PRODUCT / PROCESS CHANGE NOTIFICATION

PCN NO: PCN IN 200317-01

Change the PCB design.

IN-S126ESGHIR

Outline Dimension (Old)	Outline Dimension (New)

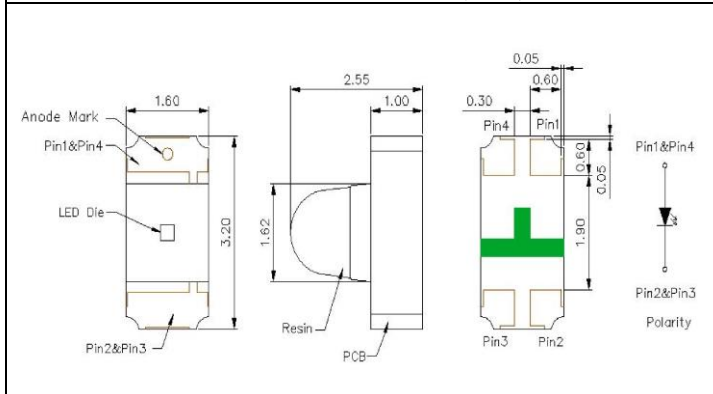
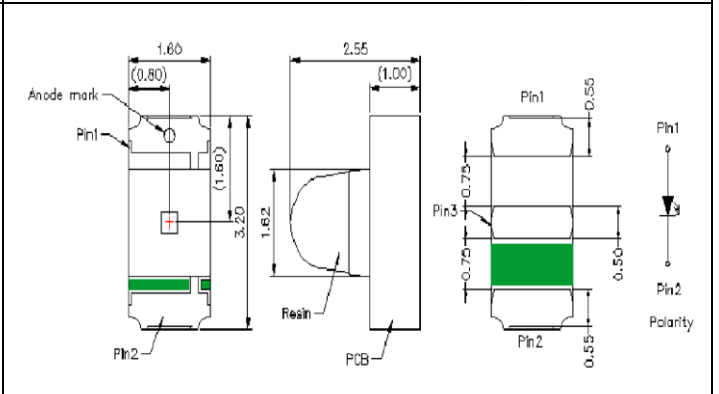
Dimension: No change of external dimension. Pin pad changed. Refer to the revision datasheet.
Specification: Same optical and electrical specification.
Material: PCB
Datasheet: Revision to reflect pin pad change.
